Town of Essex, Vermont
Application for Zoning Permit
 (Building Permit)

Application Date 1/1/22
 Permit Number 2022-44

TOWN OF ESSEX, VERMONT
APPLICATION FOR CURB CUT / UTILITY PERMIT

From: Daniel Gregoire
Sent: Thursday, April 28, 2022 8:01 AM
To: Sharon Kelley
Cc: Aaron Martin; Dennis Lutz; Deana Stoneback
Subject: RE: Curb Cut-70 Susie Wilson Road
Attachments: 70 Susie Wilson Road Curb Cut Approved.pdf

Susie Wilson Rd

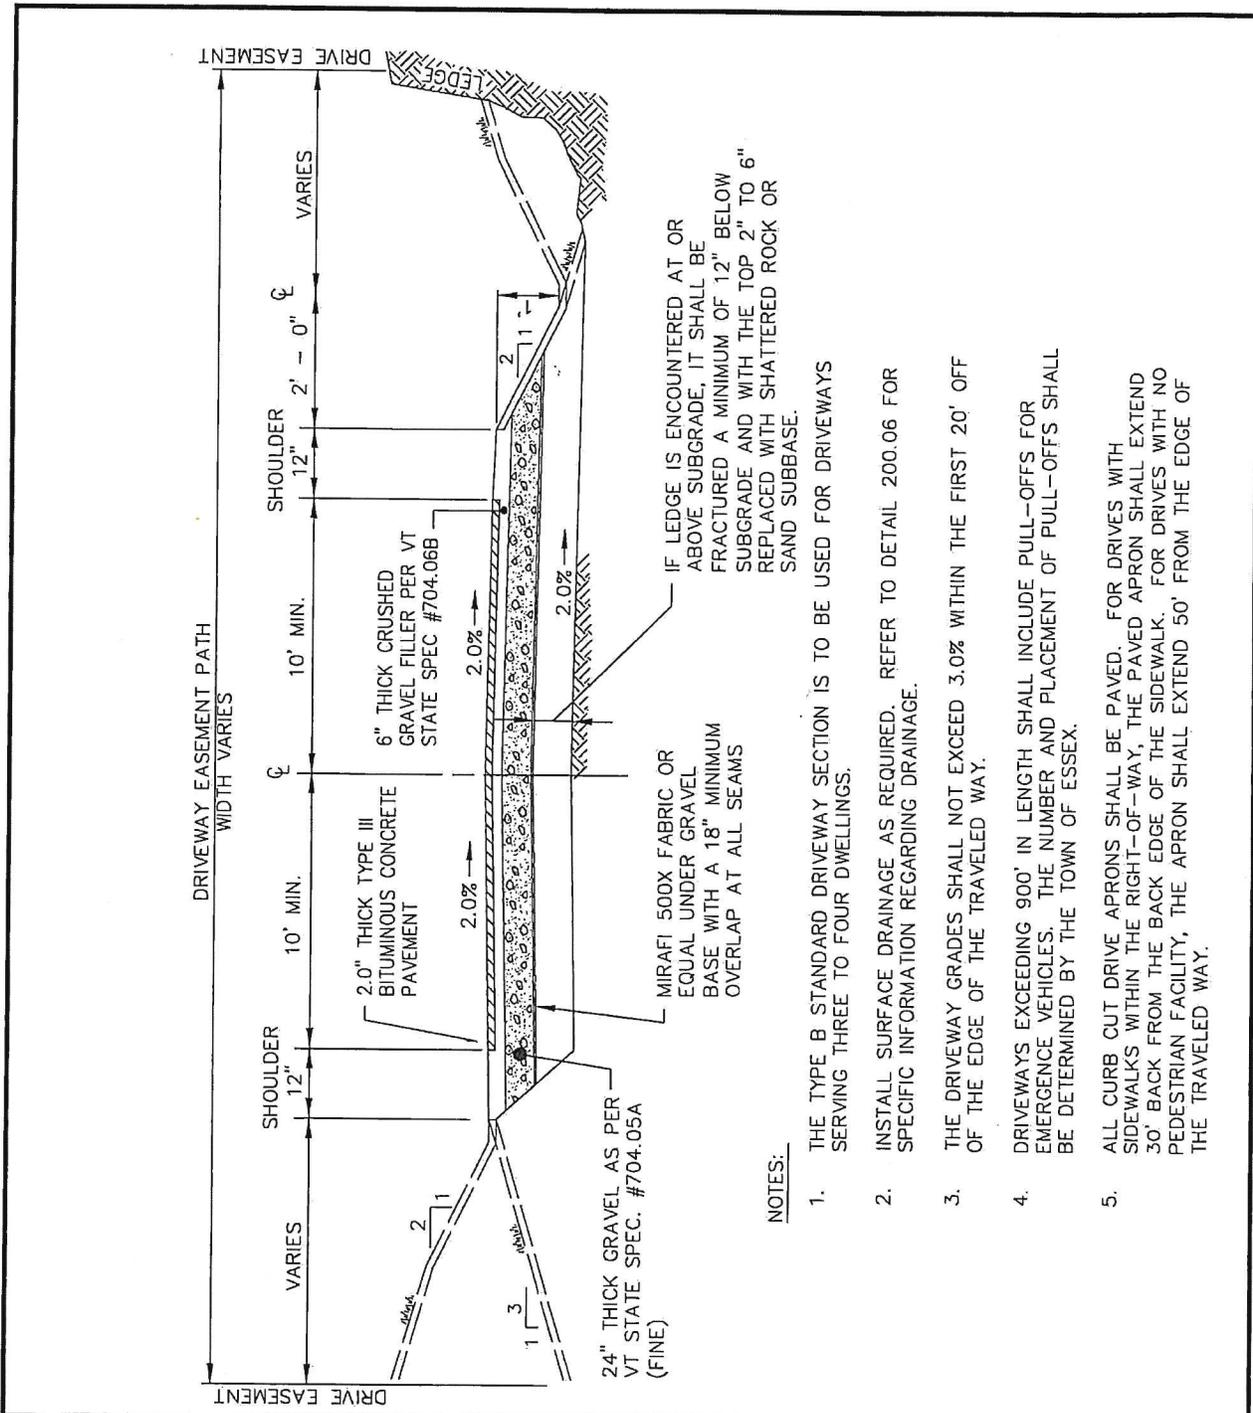
- * THE APPLICANT IS NOT TO CHANGE THE ELEVATION GRADES OF THE EXISTING SIDEWALK, STORM DRAINAGE FROM SUSIE WILSON ROAD OVER AN EXISTING LOW AREA OF SIDEWALK SHOULD BE ROUTED TOWARDS THE SIDE DITCHING OF THE ADJACENT DRIVEWAY.
- * THE DRIVE APRON SHALL BE SLOPED AWAY FROM THE ROAD ($\pm 3\%$) TO 3-4 FT FROM EDGE OF ROAD PAVEMENT TO THE APPROX. CENTERLINE OF SWALE AND BE CROWNED TO SHED WATER TO THE SWALE ON EITHER SIDE.
- * THE SIDEWALK AT THE CURB CUT LOCATION IS TO BE LEFT IN PLACE.
- * EDGE OF DRIVE RADIUS ARE TO BE 25 FT.
- * TO BE CONSTRUCTED AS PER DETAIL A-11, ATTACHED.

Re the Curb Cut for this parcel. The section of Susie Wilson road is nearly flat through this section of Susie Wilson Rd. The current configuration for storm drainage is a low spot in the sidewalk that allows for water to get off of that side of Susie Wilson Road at that location. It isn't optimum but it's what we have and it currently ensures that stormwater doesn't crest over centerline when it rains or puddle too deeply along the shoulder. The Applicant has informed me that he would like this dip in the sidewalk to be removed and replaced with a new, level section sans-dip. This would obviously lead to problems down the line.

Before I issue a curb cut for any location I have to take into account storm water mitigation which usually consists of calling out for some ditch digging/cleaning work and a culvert installation under the drive apron. This location, however, will need some actual engineering to figure out where the storm water within the Susie Wilson Road ROW is going to go once the curb cut has been installed. This is a service that our office does not offer to applicants.

The attached plan submitted for curb cut does not take storm water into account and I would need to see a proposal from the applicant showing how storm water will be mitigated with the installation of the curb cut before I sign off on a permit for the address.

We were able to engineer the stormwater issues without too much disturbance. The applicant has agreed that leaving the dip in the sidewalk is the best plan and he has agreed to swale the water from the dip to the ditching along his dad's driveway. He will have to grade his apron such that water doesn't pond in the road in front of the driveway and also doesn't puddle in his new apron, hence the required apron crown and short section sloping away from the road. He should consider asking for an inspection prior to paving in case his grading is off. I would hate to have pull new pavement to correct errors in the fine grading of his subbase. (It is a tricky build for anyone who isn't already proficient at this sort of thing.) A second inspection will be required for the final product.
